Access Compliance Report Public Rights-of-Way (Curb Ramps)

Intersection ID: 18709 Main Street: FOX RUN DR Cross Street: MONROE_RD Location: NE **ADA ID: 278FCED4F0E9** Ramp Type: PerpDiag Initial Pass/Fail: Fail **Overall Compliance: No Severity Score:** 37.5

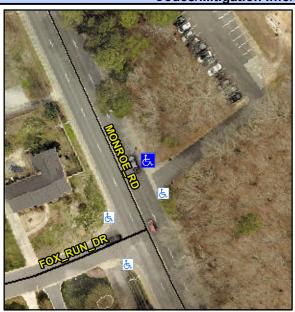
Field Measurements/Component Compilance					
Compliance Description		Data	Compliance Description		Data
N/A	Ramp Length (in)	60.0	No	Ramp Slope (%)	13.6
Yes	Ramp Width (in)	48.0	No	Ramp XSlope (%)	6.6
N/A	Flare Type LT	N/A	N/A	Flare Type RT	N/A
N/A	Flare Slope LT (%)	N/A	N/A	Flare Slope RT (%)	N/A
N/A	Flare Traversable LT?	N/A	N/A	Flare Traversable RT?	N/A
N/A	Landing Length (in)	N/A	N/A	DWS Provided?	N/A
N/A	Landing Width (in)	N/A	N/A	DWS Contrast?	N/A
N/A	Landing Slope (%)	N/A	N/A	DWS Length (in)	N/A
N/A	Landing X Slope (%)	N/A	N/A	DWS Full Width?	N/A
N/A	Landing Curb? (Y/N)	N/A	N/A	DWS Offset (in)	N/A
N/A	Shared Landing?	N/A			
N/A	Gutter Ponding?	N/A	N/A	Gutter Slope (%)	N/A
N/A	Gutter Lip Ht (in)	N/A	N/A	Gutter X Slope (%)	N/A
N/A	Painted X Walk1?	No	N/A	Painted X Walk2?	No
	X Walk 1 Direction	To W		X Walk 2 Direction	To S
N/A	X Walk 1 Width (in)	N/A	N/A	X Walk 2 Width (in)	N/A
	X Walk 1 Slope (%)	6.8		X Walk 2 Slope (%)	2.0

X Walk 1 X Slope (%)	0.6		X Walk 2 X Slope (%)	9.2
N/A	Ramp inside XWalk1?	N/A	N/A	Ramp inside XWalk2?	N/A
	Road Slope (%)	4.8	N/A	Clear Space?	N/A
	Road X Slope (%)	6.8	N/A	Clear Space to XWalk (in)	N/A
N/A	Any Obstructions?	N/A	N/A	Storm Grate/Utility Hazard?	N/A
	Obstruction Type			Storm Grate/Utility Type	
		N/A			N/A
			Yes	Surface Condition? (G/P)	Good

Possible Solutions: Remove & Replace Curb Ramp With **Two New Directional Ramps or** Equivalent. Surveyor Notes: N/A

PROW/ADA: Not Found, R304.2.2, R304.5.3 Total Cost: 3200.00
